ADDENDUM NO. 03

April 2, 2021

**Stark Metropolitan Housing Authority
Gage Gardens Rehabilitation
TC Project No.: 37-A-20**

3 STAIR TOP DETAIL
A601 SCALE: 1 1/2" = 1'-0"

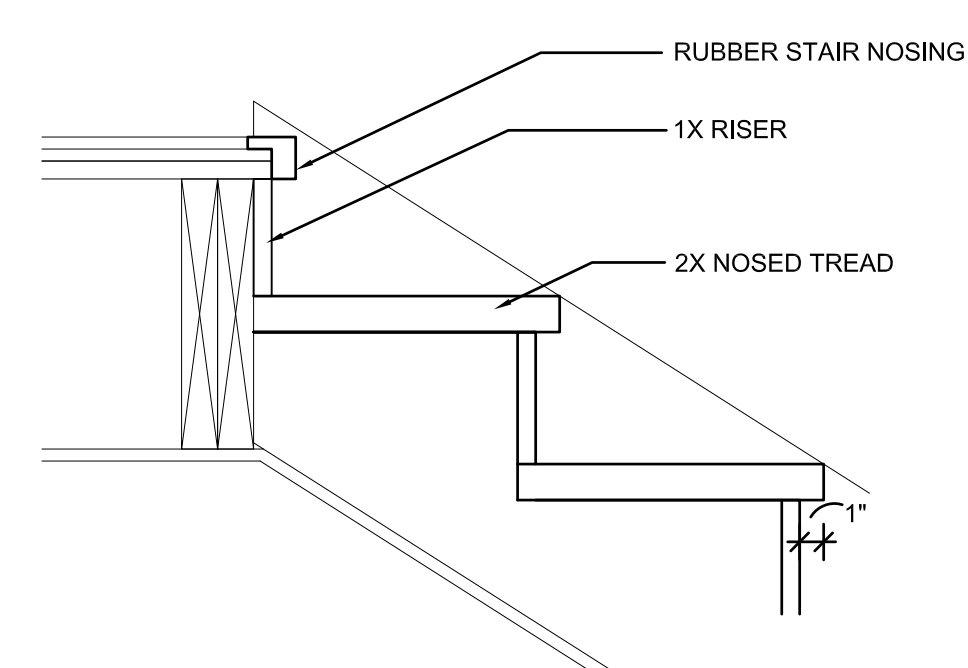
Handrails are to return to the wall at the top and bottom of the stairs. Detail 3/A601 has been revised.

14 STAIR SECTION
A602 SCALE: 3/8" = 1'-0"

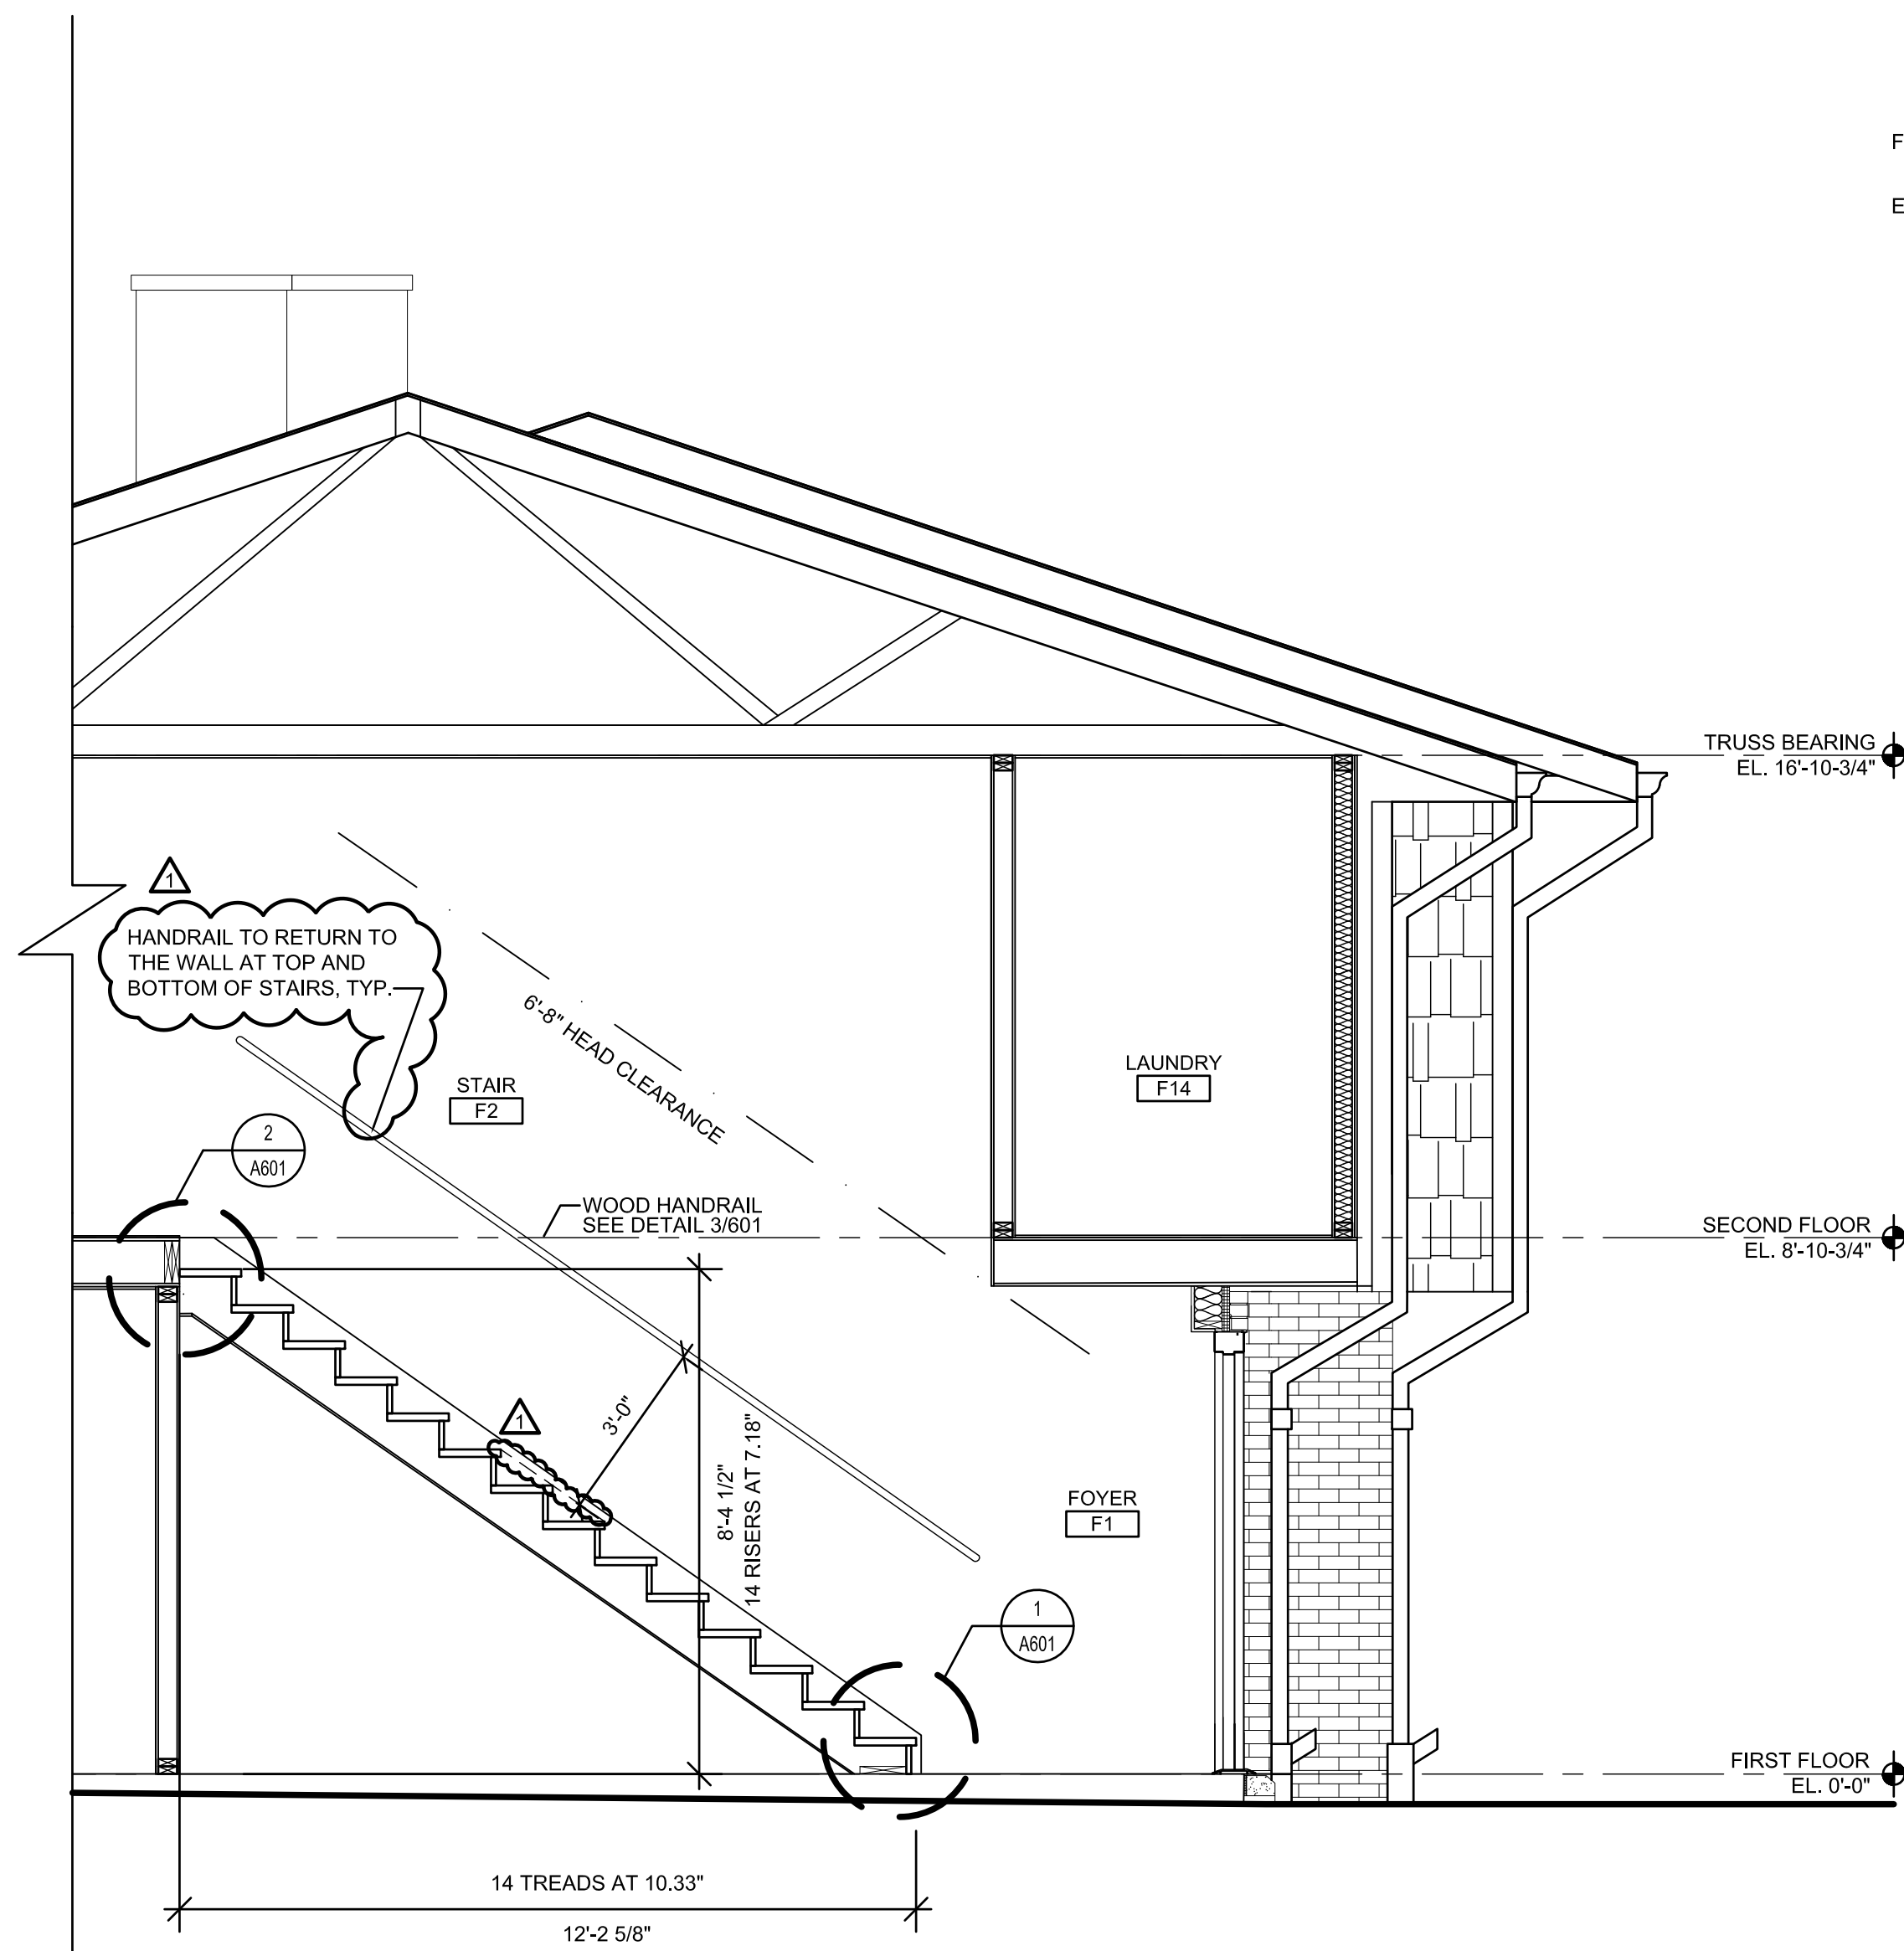
Handrails are to return to the wall at the top and bottom of the stairs and the handrail mounting height has been revised in detail 14/A602.

1 BUILDING 7 PLUMBING FIRST FLOOR PLAN
 P107A 1/4" = 1'-0"

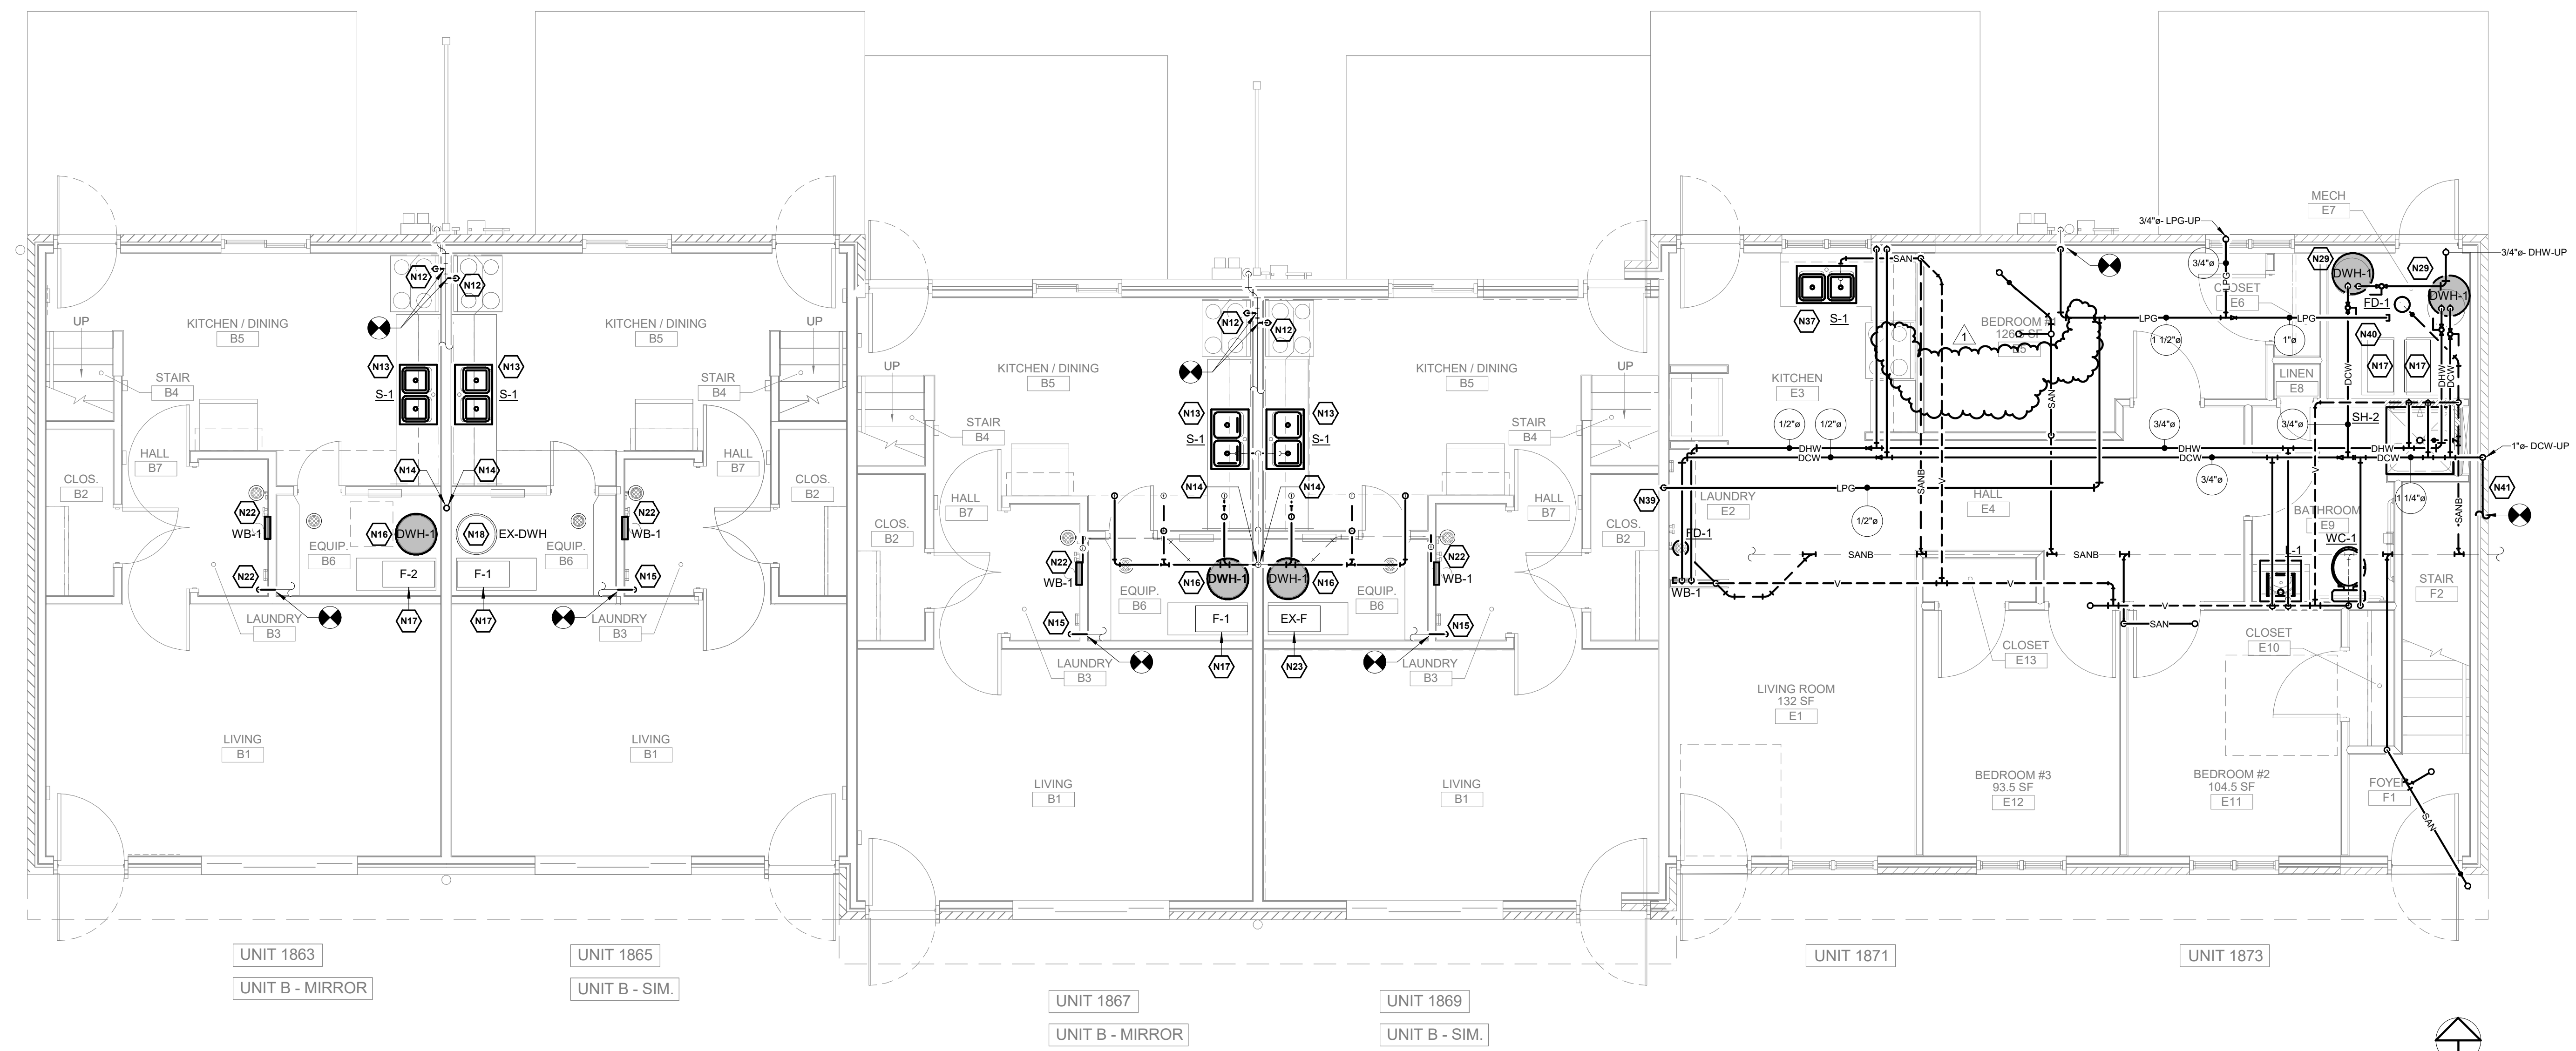
Response: Gas ranges will be utilized in all units except the UFAS units. The ranges in the UFAS will be drop-in electric as specified. See specification revisions identified in this addendum. Also, refer to drawings P107A, P108A and E502 for revised gas piping and electrical in the UFAS units.

KEYNOTES	
N12	EXTEND 1/2" NATURAL GAS PIPING FROM TIE-IN POINT SHOWN TO RANGE CONNECTION WITH SHUT-OFF VALVE.
N13	INSTALL NEW SINK. EXTEND ALL ASSOCIATED PIPING FROM EXISTING TO NEW FIXTURE.
N14	INSTALL NEW ABOVE GROUND SANITARY PIPING FROM GRADE TO NEW PLUMBING FIXTURES. FOLLOW SAME ROUTING AS EXISTING. REFER TO TYPICAL PLUMBING ISOMETRICS.
N15	EXTEND 1/2" NATURAL GAS PIPING FROM TIE-IN POINT SHOWN TO DRYER CONNECTION WITH SHUT-OFF VALVE.
N16	INSTALL NEW DOMESTIC WATER HEATER. EXTEND ALL ASSOCIATED PIPING AND FLUE DUCT FROM EXISTING TO NEW EQUIPMENT.
N17	EXTEND NATURAL GAS PIPING FROM EXISTING TO NEW EQUIPMENT.
N18	DOMESTIC WATER HEATER TO REMAIN.
N22	INSTALL NEW WASHING MACHINE WALL BOX. EXTEND ALL ASSOCIATED PIPING FROM EXISTING TO NEW FIXTURE.
N23	FURNACE TO REMAIN.
N29	INSTALL NEW DOMESTIC WATER HEATER. EXTEND 3/4" DCW AND DHW LINES TO / FROM WATER HEATER.
N37	INSTALL ALL NEW PLUMBING FIXTURES THIS UNIT. EXTEND SANITARY, VENT AND DOMESTIC WATER PIPING TO FIXTURE AS SHOWN. REFER TO SANITARY ISOMETRICS FOR SIZES AND ROUTING. REFER TO PLUMBING FIXTURE SCHEDULES FOR WATER CONNECTION SIZES.

SMOKE DETECTOR DETAILS

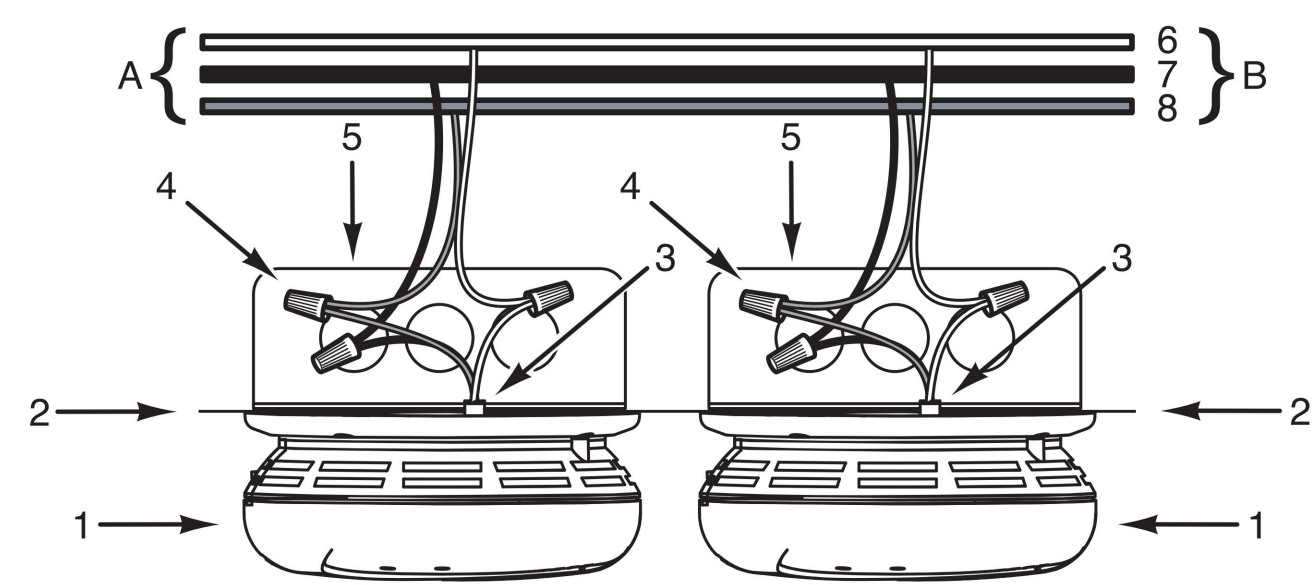
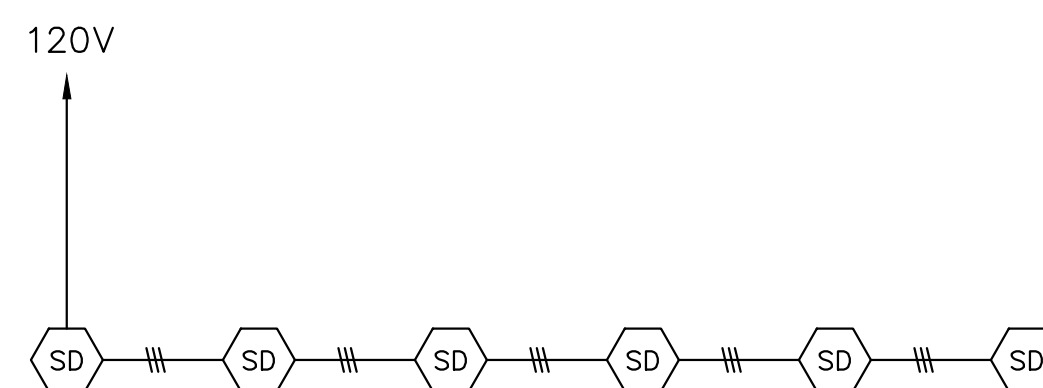
11. Same question for 2307/2309.
Response: Both units will use existing meters and circuit breakers. See item 9 response for the feeder type.
12. It looks like the existing smoke detectors are not interconnected. Please clarify, since the detail on E502 requires them to all be wired together.

Response: The smoke detectors shall be new and interconnected per the details on the electrical drawings.
13. Regarding the Gage Gardens Rehabilitation project, is the Builder's Risk insurance covered by the Owner or the GC? Please let me know.
